Work Order ID 102501

Item Name: Crosstube Aft

DART AEROSPACE LTD		Work Order:	102501
Description: Crosstube High Aft (205/212)		Part Number:	D212-664-201
Inspection Dwg: D212-664-241	Rev: D	Page 1 of 1

DRAWING NO. D212-664-241	TITLE CROSSTUBE ASSY (205/212 HI AFT)	REV. D	DART AEROSPACE LTD ENGINEERING ORDER		D.E.O. NO. D212-664-241-D-1	SHEET NO. SHEET 1 OF 2	SCALE NTS
DRAWN	CHECKED	MFG. APPR.	APPROVED	DE APPR.			
DATE 11.04.07	DATE 11.04.11	DATE 11.04.12	DATE 11/04/12	DATE 11.04.12

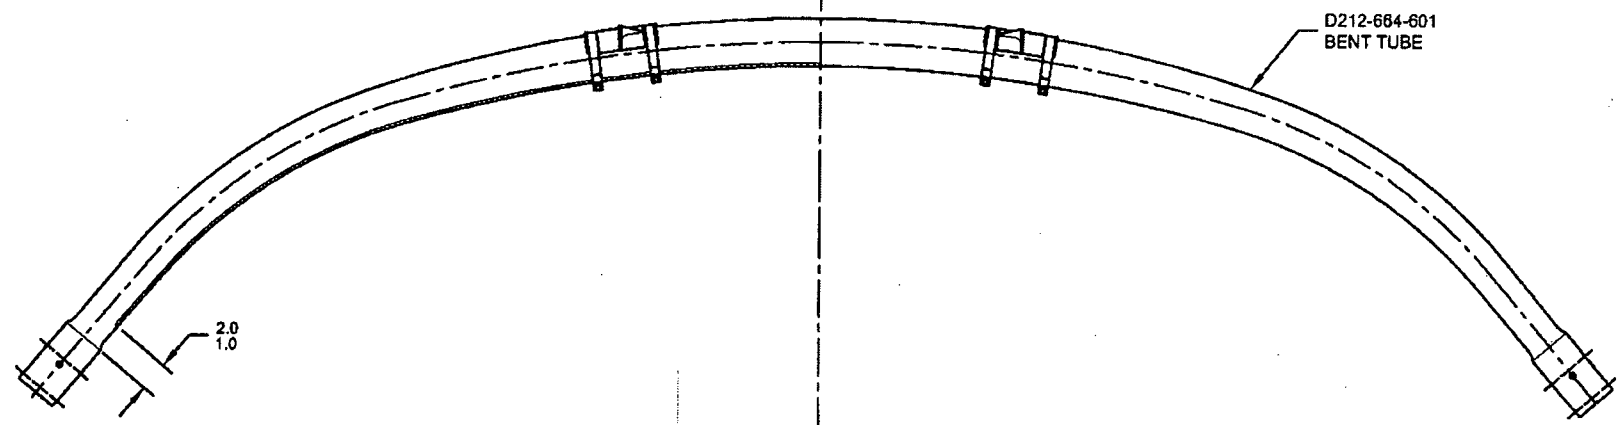
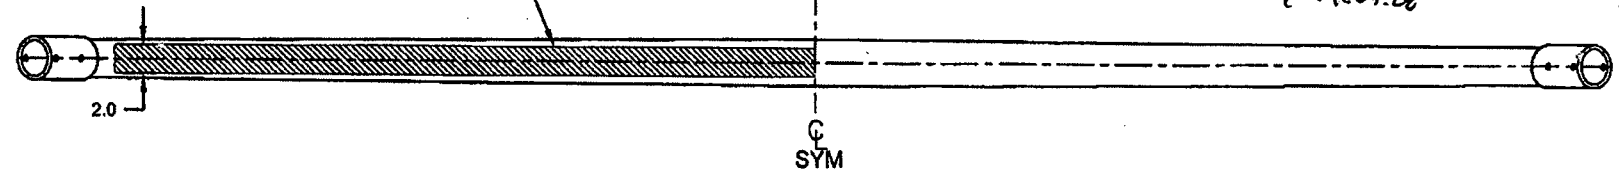
ADD AN INSPECTION WINDOW TO UNDERSIDE OF CROSSTUBE.

NOTES 2 OF SHEET 1 IS AMENDED AS FOLLOWS:

- 2) FINISH: CHEMICAL CONVERSION COAT PER DART QSI 005 4.1
PRIME INSIDE AND OUTSIDE PER DART QSI 005 4.2
MASK UNDERSIDE OF CROSSTUBE AS SHOWN (HATCHED AREA) AND
PAINT OUTSIDE PER DART QSI 005 4.2
REMOVE MASKING AND APPLY CLEAR COAT

MASK AREA PRIOR TO PAINTING,
REMOVE MASKING AFTER PAINT
AND APPLY CLEAR COAT

FIGURE 1: SUPPORT INSTALLATION

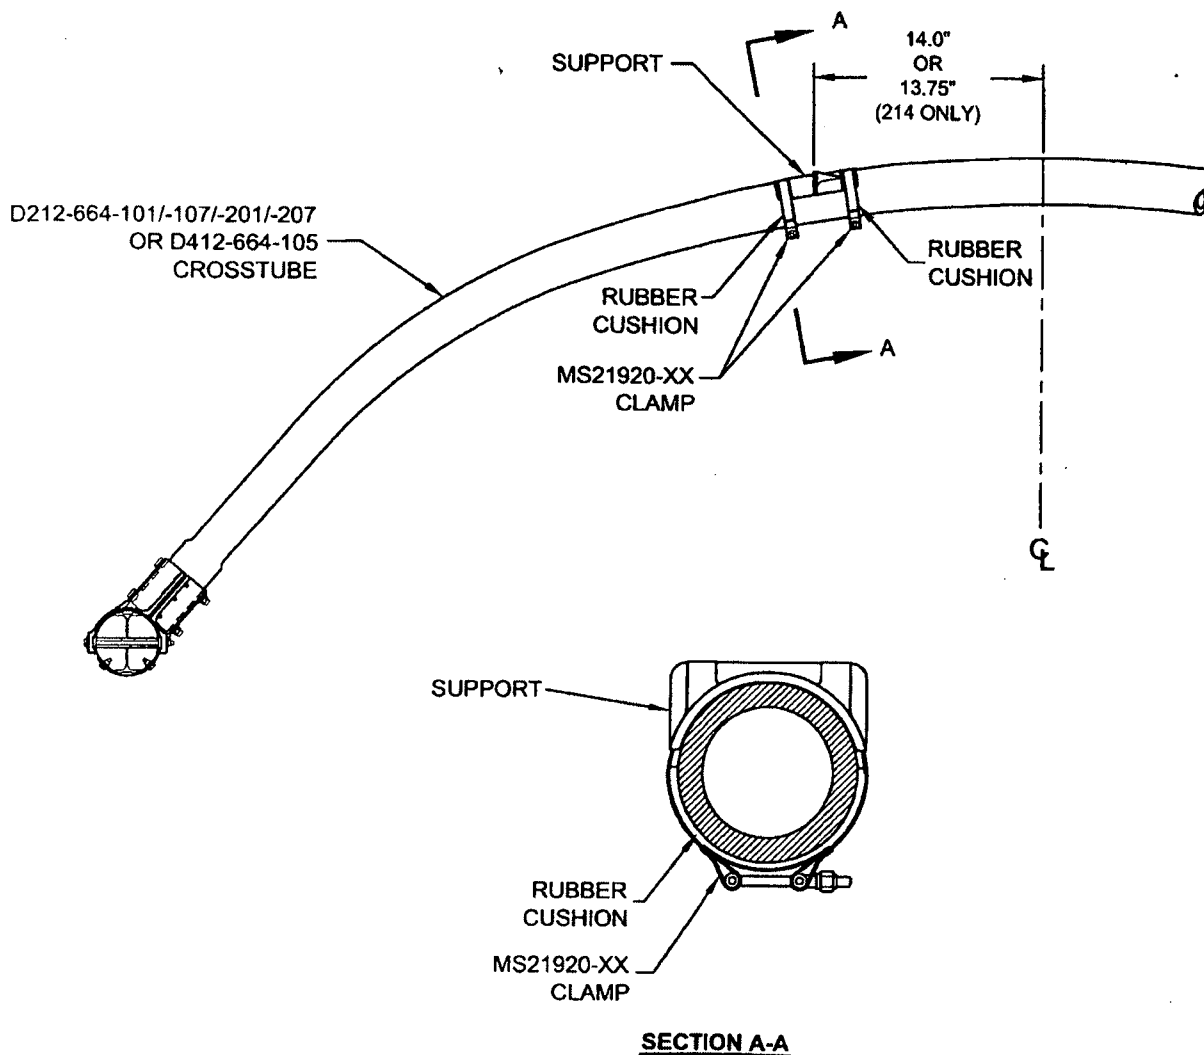
For the crosstubes listed above, section 32.4 of ICA-D212-664 is amended as follows. Use Figure 1 of this service instruction and Figures 32-2 to 32-9 of ICA-D212-664 for further reference. For crosstubes of an earlier change number, it is recommended that if the supports are removed, the supports should be reinstalled using the procedure listed below.

- 32.4.5 Apply a 0.04" to 0.07" thick layer of Proseal 890 Class B or AMS-S-8802 Class B sealant underneath applicable support and install support as shown in Figure 1 of this service instruction.

- 32.4.6 Install the clamps opposite to crosstube support as shown in section A-A of Figure 1. Install rubber cushions underneath each clamp around the bottom circumference of the crosstube up to the crosstube centerline. Torque clamps 80-100 in·lb (9.0-11.3 Nm). It is acceptable to use smaller or larger sized MS21920-XX clamps than those listed in ICA-D212-664, ensure that after torquing the clamps per this instruction, the nuts are in safety but not bottomed out

CRUSHING OF D212-664-201

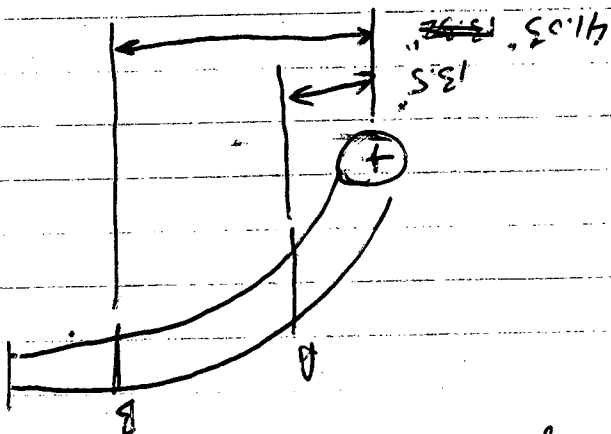
Acceptability of 8% CRUSHING

Point A: $OD = 2.548$ in $OD = 2.492$ in
